Access Compliance Report Public Rights-of-Way (Curb Ramps)

Main Street: N/A	Cross Street: NARROW_CANYON_RD	Location: SE
------------------	--------------------------------	--------------

ADA ID: RPRK211115125258	Ramp Type: Type 4 - Parallel	Initial Pass/Fail: Fail	Overall Compliance: No	Severity Score: 16
--------------------------	------------------------------	-------------------------	------------------------	--------------------

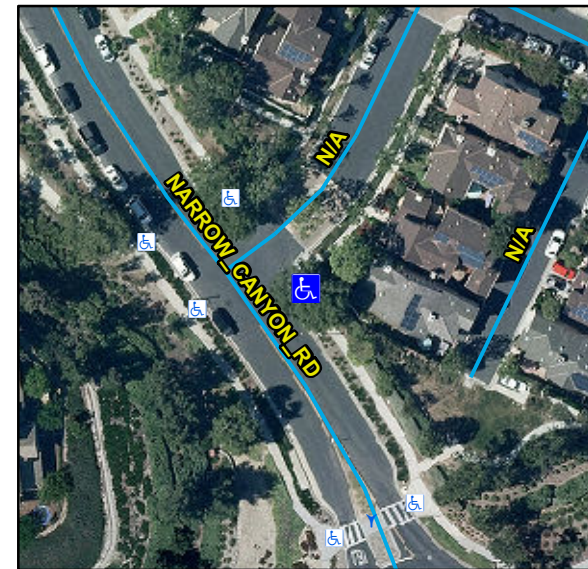
Compliance	Description	Data	Compliance	Description	Data
N/A	Ramp Length LT (in)	135	N/A	Ramp Length RT (in)	133
Yes	Ramp Width LT (in)	88	Yes	Ramp Width RT (in)	88
No	Ramp Run Slope LT (%)	11	Yes	Ramp Run Slope RT (%)	1.2
Yes	Ramp Cross Slope LT (%)	1.1	No	Ramp Cross Slope RT (%)	2.5
N/A	Landing Present	N/A	N/A	DWS Provided	N/A
N/A	Landing Length (in)	N/A	N/A	DWS Contrast	N/A
N/A	Landing Width (in)	N/A	N/A	DWS Length (in)	N/A
N/A	Landing Run Slope (%)	N/A	N/A	DWS Full Width	N/A
N/A	Landing Cross Slope (%)	N/A		DWS Offset Type	N/A
N/A	Landing Movement Obstructed?	N/A	N/A	DWS Offset Left (in)	N/A
	Landing Movement Type	N/A	N/A	DWS Offset Right (in)	N/A
N/A	Landing Shared	N/A			
N/A	Clear Space	Yes			
N/A	Clear Space To Crosswalk (in)	N/A			
N/A	Marked Crosswalk 1	No	N/A	Marked Crosswalk 2	No
	Crossing 1 Direction	N		Crossing 2 Direction	W
	Marked Crosswalk 1 Width (in)	N/A		Marked Crosswalk 2 Width (in)	N/A

N/A	Ramp Inside Crosswalk 1	N/A	N/A	Ramp Inside Crosswalk 2	N/A
	Crossing 1 Slope (%)	4.4		Crossing 2 Slope (%)	4.4
	Crossing 1 Cross Slope (%)	2.1		Crossing 2 Cross Slope (%)	3.7
N/A	Gutter Ponding	N/A	N/A	Curb Slope	8.5
Yes	Gutter Lip Height (in)	0		Road Run Slope (%)	3.9
N/A	Gutter Run Slope (%)	N/A		Road Cross Slope (%)	3.2
N/A	Gutter Cross Slope (%)	N/A	No	Perpendicular Joint Present	No
Yes	Overall Surface Condition	Acceptable			
	Cross Gutter Present?	No		Spandrel Present?	No
	Replace Cross Gutter?	N/A		Replace Spandrel?	N/A

Possible Solutions:
Remove & Replace Curb Ramp With Two New Directional Ramps or Equivalent.
